# **Cortina Systems® LXT973 10/100 Mbps Dual-Port Fast Ethernet PHY Transceiver**

## **Specification Update**

**20 March 2007**

**Revision 10.0**

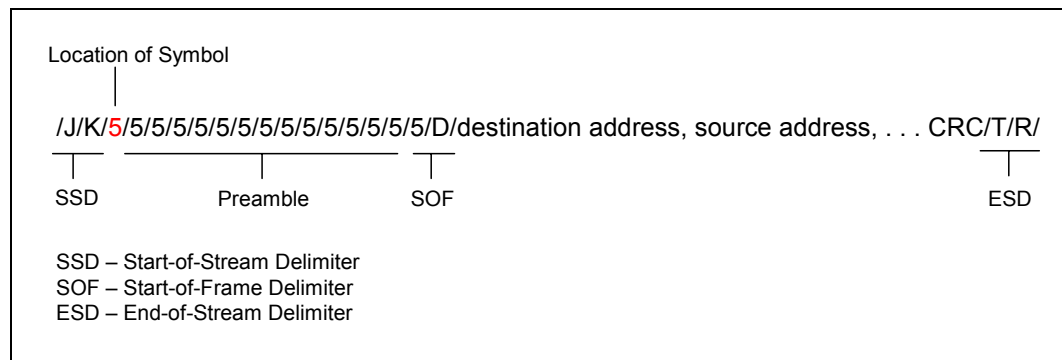
### Item 8: Changing Advertised Duplex While Link Is Up

**Problem** Writing to Register bits 4.9:5, which control duplex mode advertisement while link is up and auto-negotiation is enabled, immediately changes the PHY mode of operation to the new duplex mode. When written, the values in this register are not intended to affect PHY operation until a new auto-negotiation cycle is completed.

**Implication** A possible mixed-duplex operation will exist during the time between Register bits 4.9:5 writes and the start of a new auto-negotiation process.

**Workaround** Write Register bits 4.9:5 immediately before the start of a new auto-negotiation process.

**Figure 4 Ordering Information – Sample**

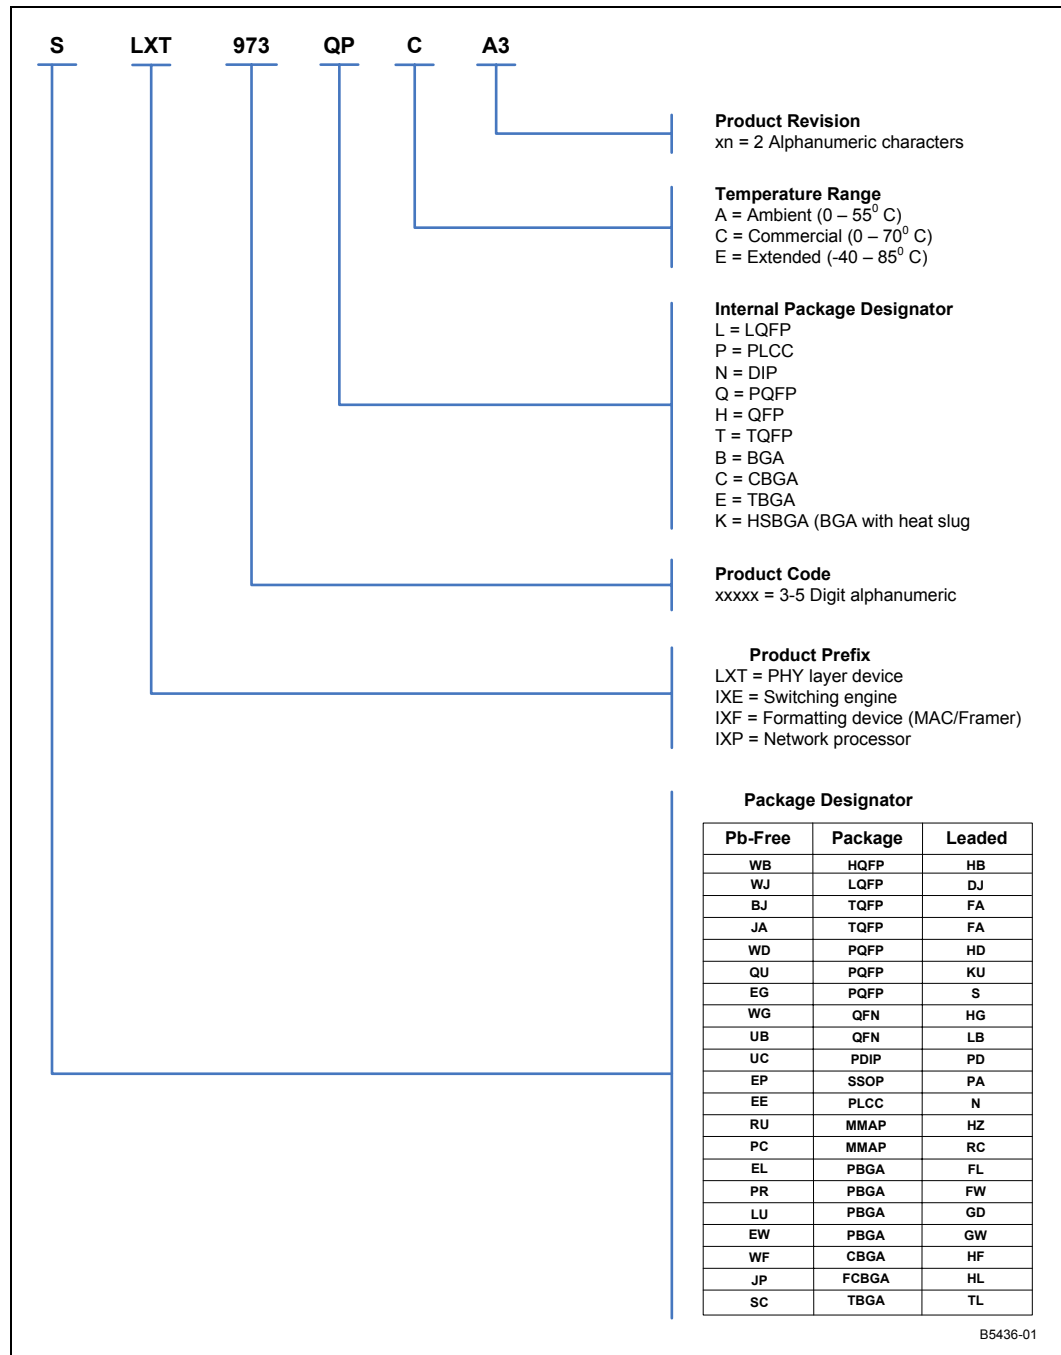
### Item 1: Product Ordering Information

Table 3 lists the LXT973 PHY Transceiver product ordering information. Figure 4 provides the ordering information matrix.
